NOTICE OF CONTRACT AMENDMENT

DATE ISSUED:	<u>December 28, 2017</u>
CONTRACT NO:	<u>18-020</u>
CONTRACT TITLE:	<u>Columbia Pike Street Improvements</u>
AMENDMENT NO:	<u>2</u>

**ARLINGTON COUNTY, VIRGINIA
AGREEMENT NO. 18-020
AMENDMENT NUMBER 2**

PLAZA CONDOMINIUM RETAINING WALL RETROFIT

RETAINING WALL ELEVATION
(Not to Scale)

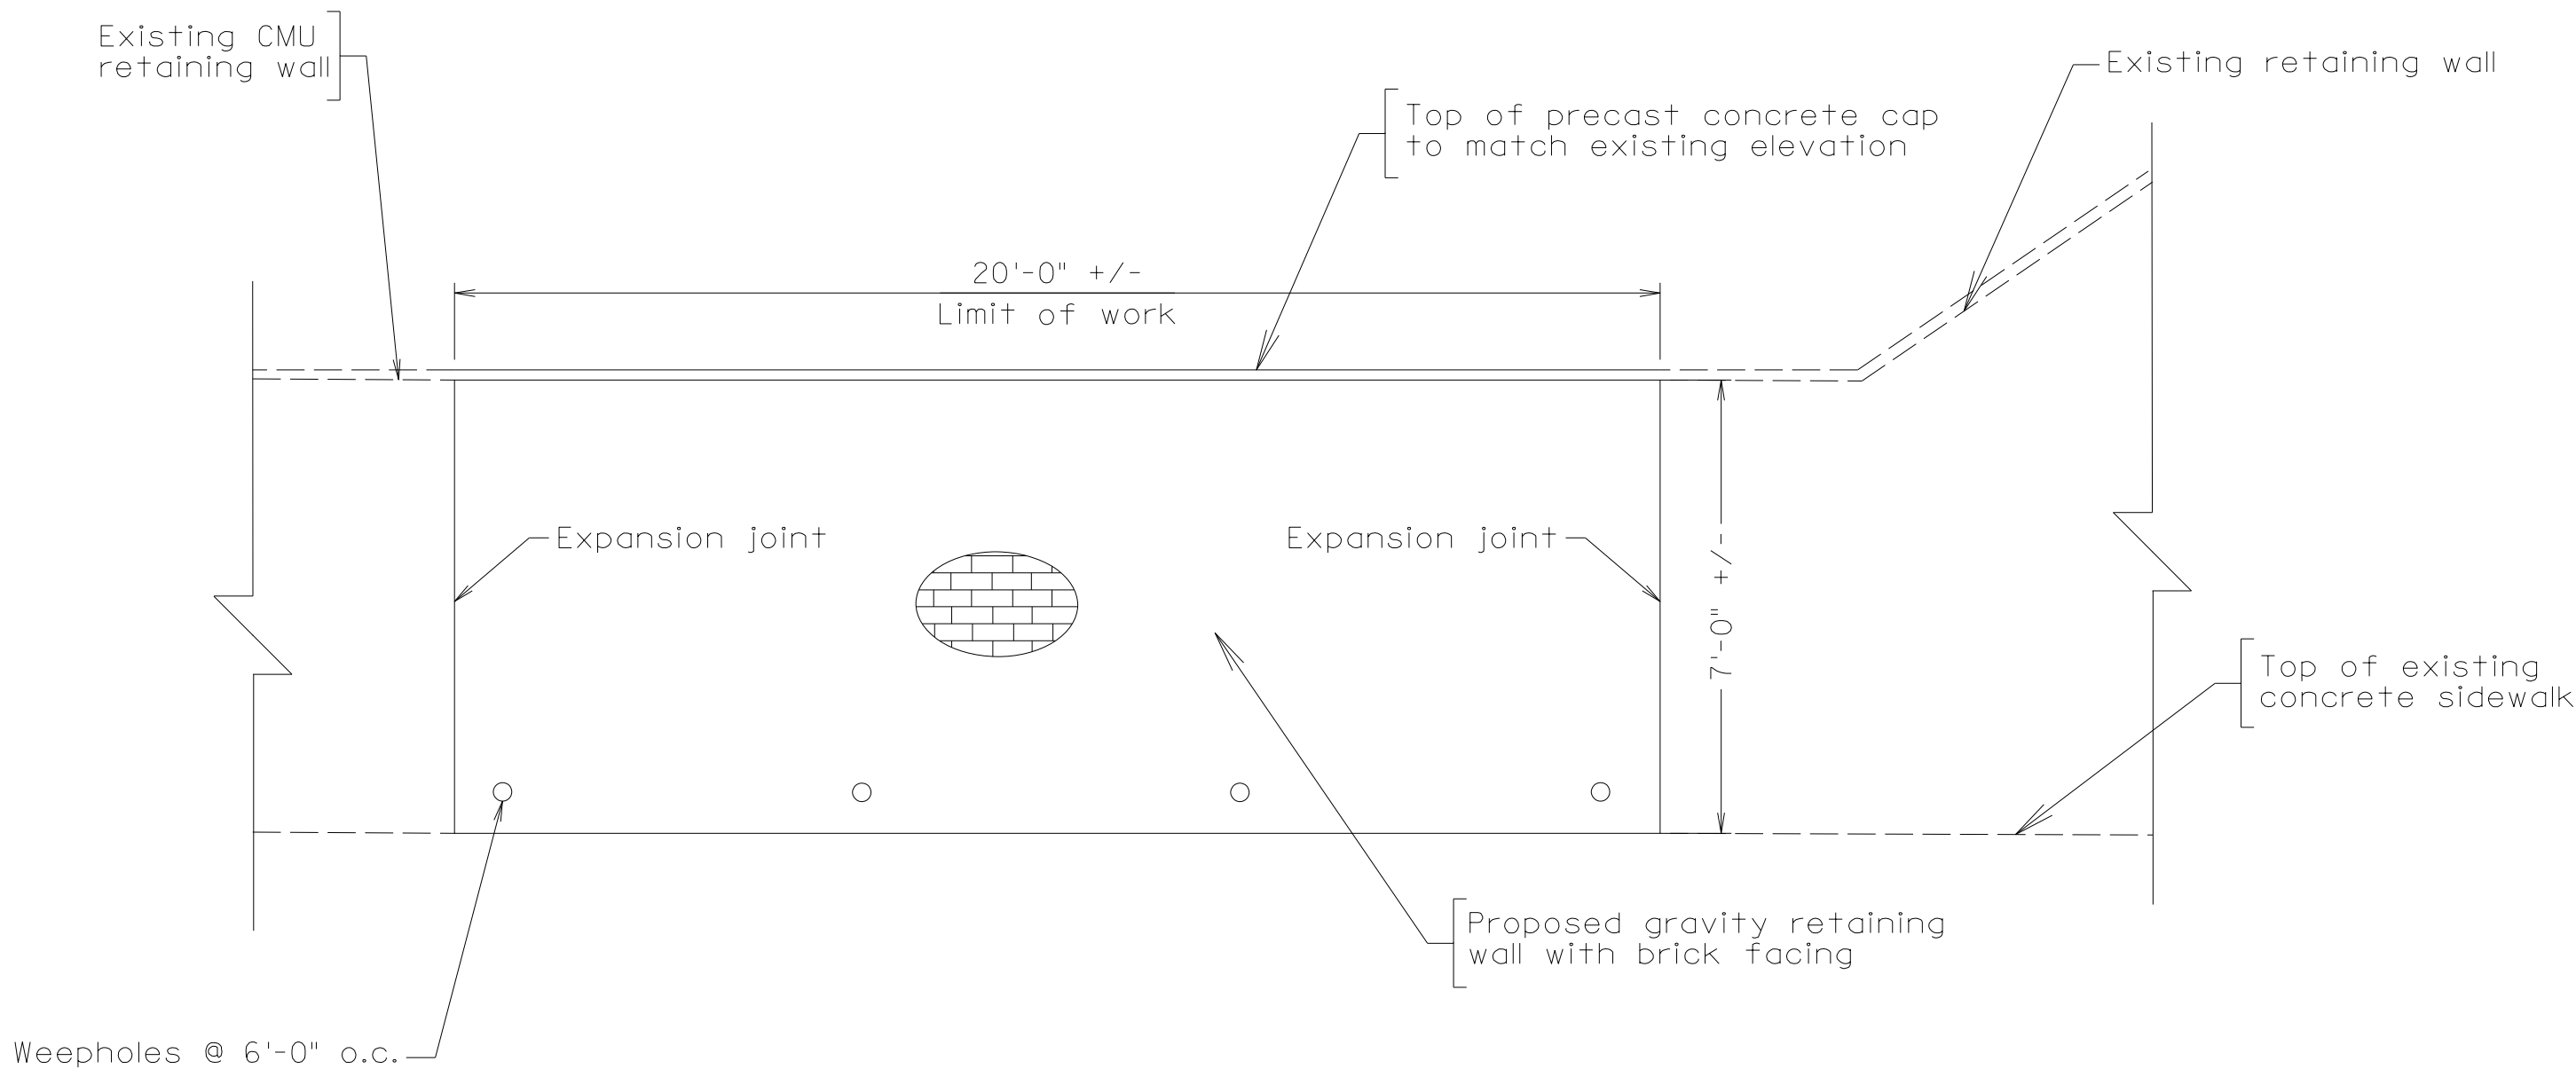
•Note: The wall dimensions to be verified in the field.

2. The VDOT Concrete Gravity Retaining Wall Standard RW-3 with brick facing shall be used as the wall replacement for the damaged CMU wall. All retaining wall requirements shown in the standard, such as soil bearing, drainage, porous backfill, expansion joints, and joint sealer, shall be followed unless otherwise shown in these drawings.

4. Contractor shall take extra precaution in the excavation and removal of the damaged retaining wall and footing to prevent damage to the adjacent existing retaining walls, existing underground utilities, and the roots of the adjacent existing trees.

5. Vertical expansion joints shall be provided between the new retaining wall replacement and the adjacent existing retaining walls. The ends of the existing retaining walls shall be vertical and shall be finished to receive the embedded half of the expansion joint materials.

7. After the retaining wall construction, the wall is expected to have short term settlement. The difference in elevation between the new and the existing wall will be compensated by the new precast concrete cap on top of the new wall. The top elevation of the new concrete cap shall match the top elevations of the adjacent existing walls.
